WARRANTY BULLETIN SAFETY CAMPAIGN

Can-Am® On-Road Spyder™

Campaign no.: 2022-0019

February 9, 2023 Subject: **Rearview Mirror Lenses May Dislodge - Decreased Visibility** No. **2022-19**

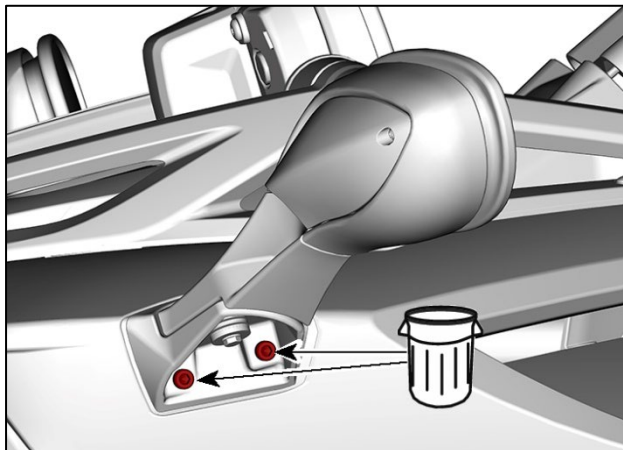
- Install the new mirror housing cap. Place the ridge of the cap in the cavity and press the cap to hook it.

- Secure in place using the new retaining screw.

TIGHTENING TORQUE	
Mirror Cap Retaining Screw	2.5 N•m ± 0.5 N•m
	(22 lbf•in ± 4 lbf•in)

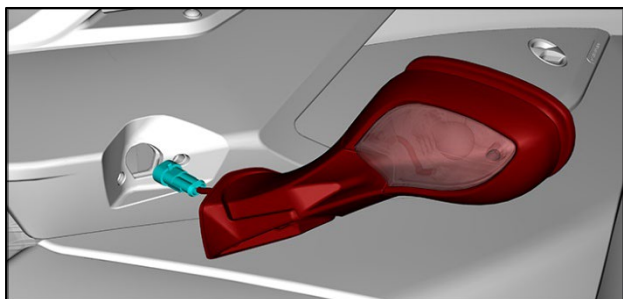
1. Remove and discard the two housing retaining screws.

TIGHTENING TORQUE	
Mirror Housing Retaining Screw	3.5 N•m ± 0.5 N•m (31 lbf•in ± 4 lbf•in)
